Final Environmental Impact Report

Carpinteria Advanced Purification Project

SCH# 2019011016

2. RESPONSE TO COMMENTS ON DRAFT EIR

Figure 2-1: 100-Foot Radius from Revised Injection Well Location within Well Site #3

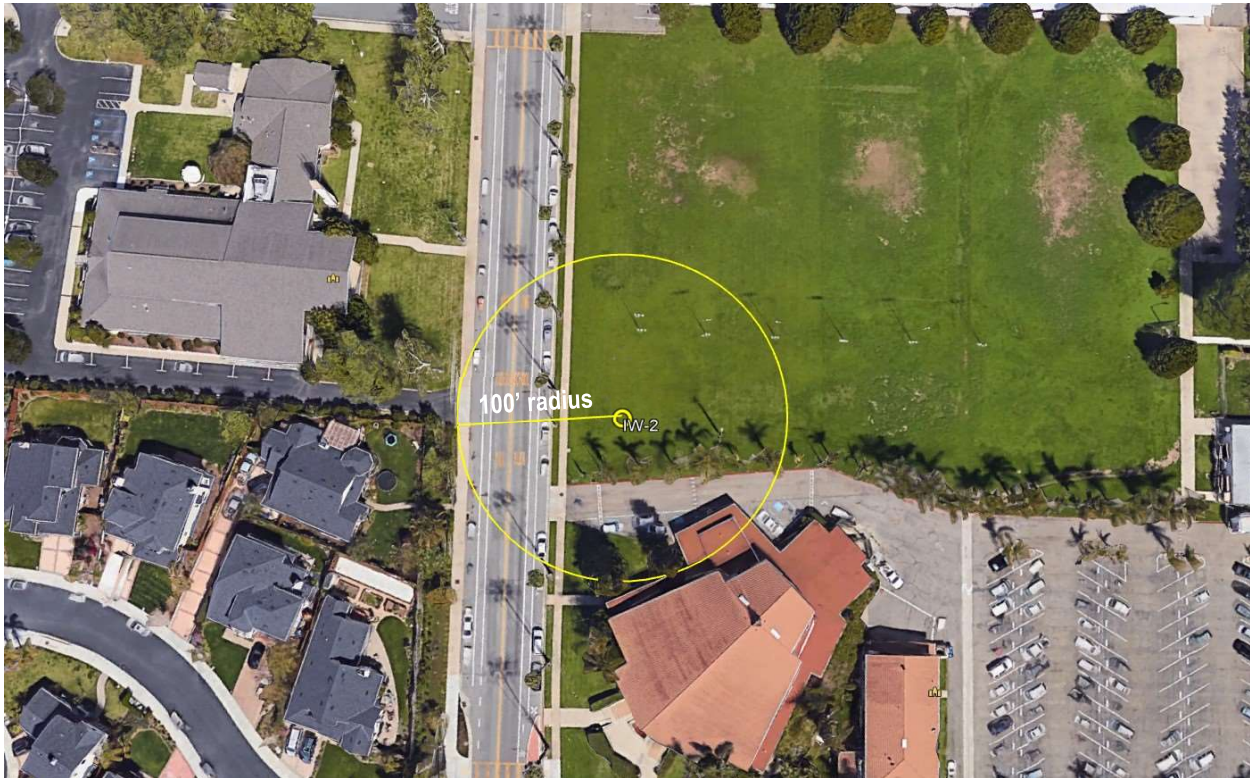
Master Response – Noise and Vibration addresses the concerns related to the proximity of proposed injection well at St. Joseph’s Church to residences and the church’s Youth Center building. As described in that response, CVWD has been coordinating with St. Joseph’s Church to relocate the injection well within Well Site #3 further from these structures.

As described in Master Response – Noise and Vibration, the injection well at Well Site #3 would be relocated further from Seacoast Homeowner's Association residences than as shown in the visual simulation for Well Site #3 in Figure 3.1-2 on page 3.1-9 of the Draft EIR. The revised location, further from Seacoast Homeowner's Association is shown in Final EIR Figure 2-1 (above).

Since publication of the Draft EIR, CVWD has continued its discussions with St. Joseph's Church to refine the location of the injection well within Well Sites #2 and #3. In response to feedback, CVWD and St. Joseph's Church have elected to relocate the injection well within Well Site #3 away from the fence behind 1532 Nantucket Court to the corner of the field near Linden Avenue, between the existing light posts and driveway, as shown in Final EIR Figure 2-1 (see following page). Relocating the injection well within Well Site #3 would reduce the number of residential properties that fall within 100 feet of the temporary construction easement for the injection well site from four to none. When measured from the injection well itself, no residential properties fall within 100 feet of the well where drilling would occur (see Figure 2-1). In accordance with refined design drawings for the injection well at the new location within Well Site #3, the injection well would be housed in an underground vault with aboveground controls on a concrete pad nearby. The aboveground controls would be shielded from the street by a block wall designed to also function as a church sign. A visual simulation of the revised injection well is provided in Final EIR Figure 2-2 (see following page, and page 3-21 in *Section 3 Errata* of this Final EIR). The Project Description has identified that only one backflush tank would be constructed and been revised to clarify that the backflush tank would not be constructed at Well Site #3 (see *Section 3 Errata* of this Final EIR, page 3-18). Figure 2-2 shows no backflush tank at the revised location of the injection well at Well Site #3.

As described in Master Response – Noise and Vibration, and shown in Final EIR Figure 2-1 (above), the proposed injection well at Well Site #3 has been relocated near Linden Avenue, on the far side of the field from the Seacoast Village community. Relocation of the injection well would reduce potential noise and vibratory impacts to nearby residences.

Figure 2-3: Injection Well Site #5 Showing 50-foot Setback from Franklin Creek

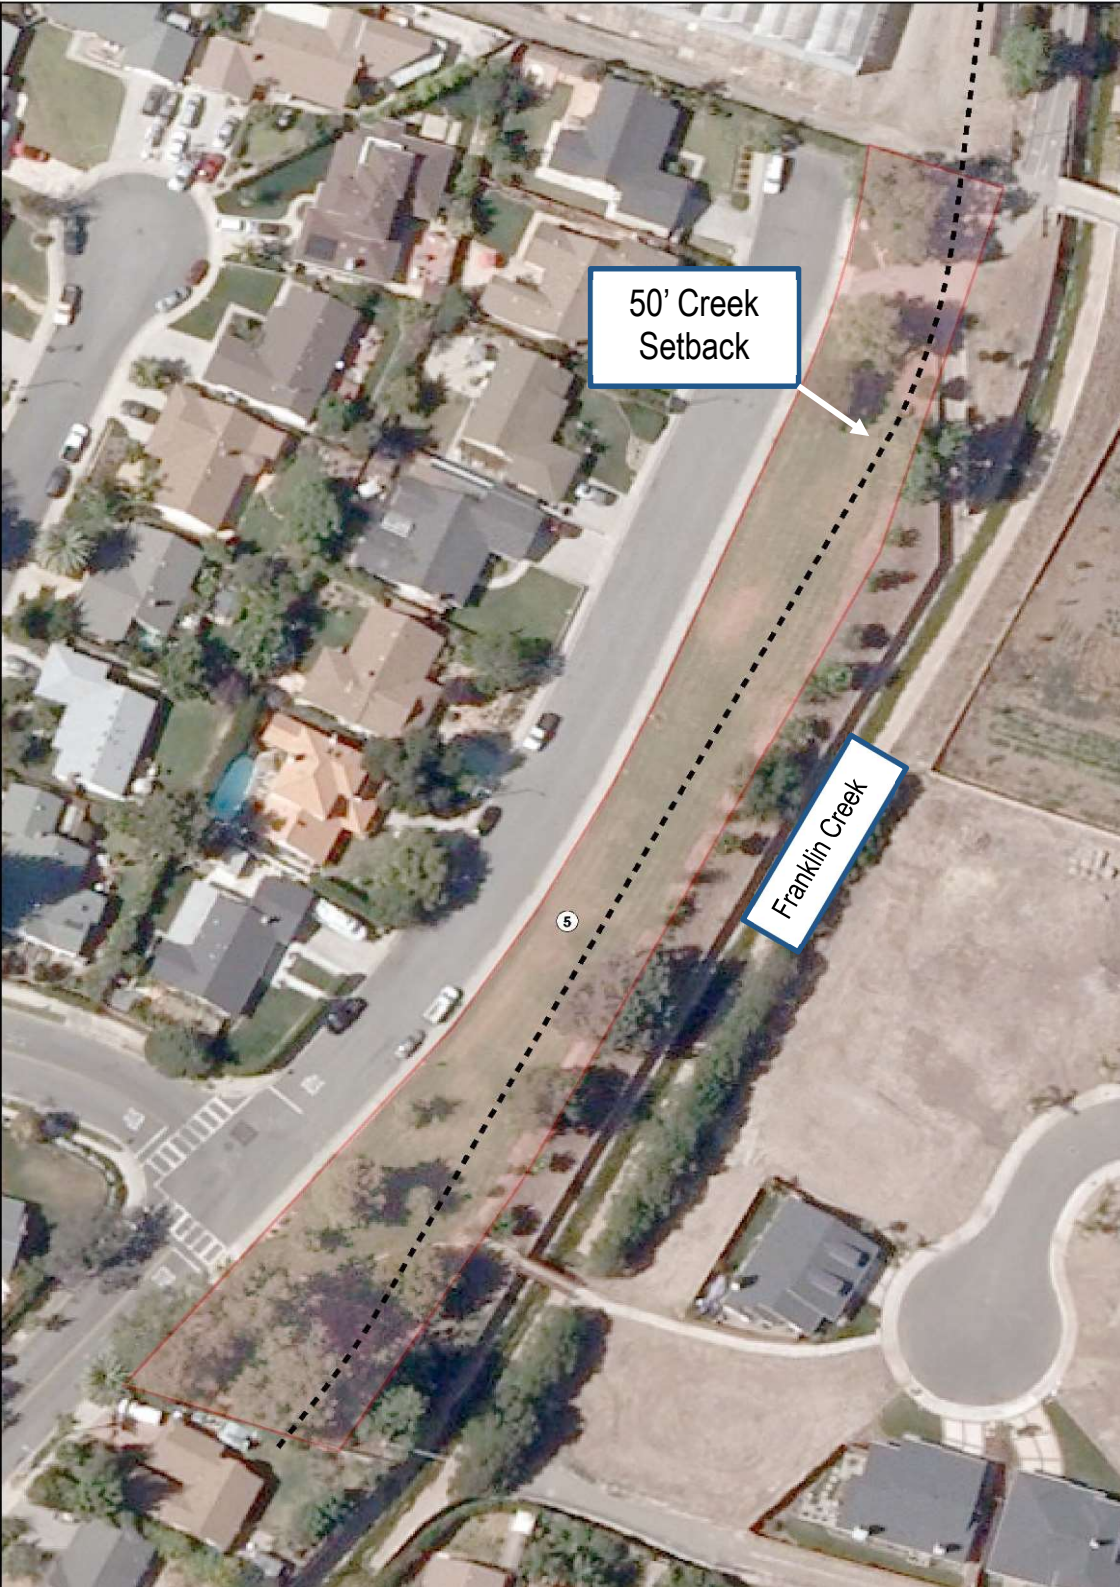
I hereby request that you immediately provide me with any photos, sketches, diagrams, drawings, and written materials showing the exact location of alternative site #6 at the Franklin Creek Park which was quickly dismissed as a viable option because a single tree would allegedly have to be removed. As you know, this location is city owned property and a much more appropriate site than alternative site #2 right up against or adjacent to residential property. If required, I can file a Public Records Act Request pursuant to Government Code Section 6250, *et seq.* to acquire this information

The Draft EIR has been structured to provide project-level CEQA coverage for the location of injection wells anywhere within the identified Well Sites. While only three Well Sites would ultimately be selected for build out (and initially only two for the first phase of the Proposed Project), six parcels were initially considered during the Initial Study, and was refined to five parcels as additional site evaluations were conducted. Well Site #5 at Franklin Park was found to be infeasible because it would require construction within the 50-foot creek setback, in violation of the City's *General Plan/Local Coastal Plan* (City of Carpinteria, 2003), constraining the construction area and well location. Additionally, the use of Well Site #5 would require removal of a high number of Oak trees. Final EIR Figure 2-3 (see following page) shows Well Site #5 at Franklin Park and the 50-foot setback. As seen in the figure, the remaining portion of the site would constrain the potential well location within the site. Although aerial photos showed limited number of trees, as of a site walk on January 24, 2019, the site had been planted with young coast live oak (noted in Appendix D, Biological Resources Assessment of the Draft EIR), further reducing the feasibility of the site. The City's *General Plan/Local Coastal Plan* Objective OSC-7 Conserve Native Plant Communities includes Policy OSC-7a, which calls for protection oak trees through development standards (City of Carpinteria, 2003). The oaks now growing in Franklin Park are shown in Final EIR Figure 2-4, photographed in January 2019. For these reasons, Well Site #5 was found to be unsuitable for an injection well.
